ADDENDUM No. 3
BID DOCUMENTS FOR
MANCHESTER • BOSTON REGIONAL AIRPORT
PRE-CONDITIONED AIR UNITS & GROUND POWER EQUIPMENT REPLACEMENTS
PROJECT
MHT / City Bid # FY22-805-51
AIP # 3-33-0011-TBD-2022

May 20, 2022

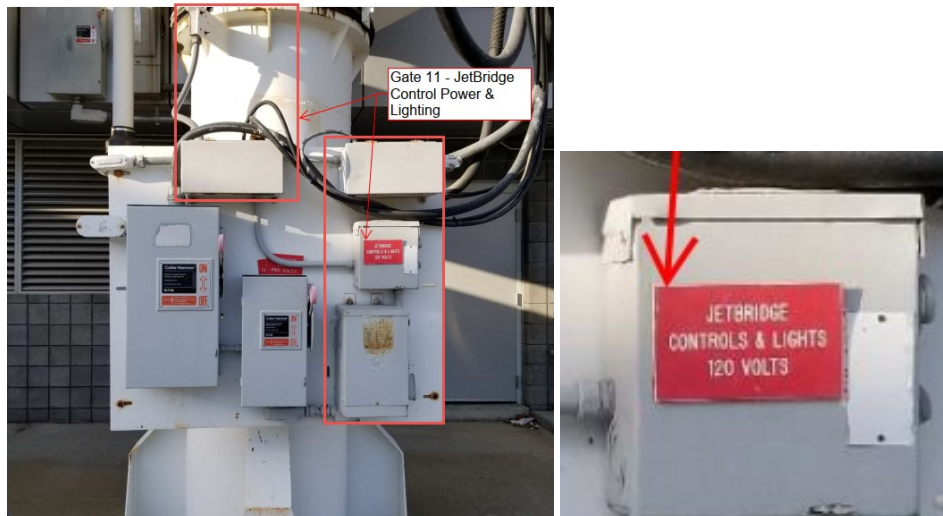
Q2. “ GATE 14 and 15 (BASE BID) Scope states: “provide and install two new 3P/150A main breaker at Feeder #1 and Feeder #2 of Meter Bank #1”. Should these both be 3P/200A breakers, as shown on Proposed drawing? “

- a. Yes. The One-Line diagram for the proposed work is correct. The replacement of the existing 150A breakers at the meter bank shall be 200A. Revise Section 00 20 00 Scope of Work Part I. General, 1.1 SCOPE, Subsection D, GATE 14 and 15 (BASE BID), Installation description to read:

- Provide and install two new 3P/200A main breakers at Feeder #1 and Feeder #2 of Meter Bank #1
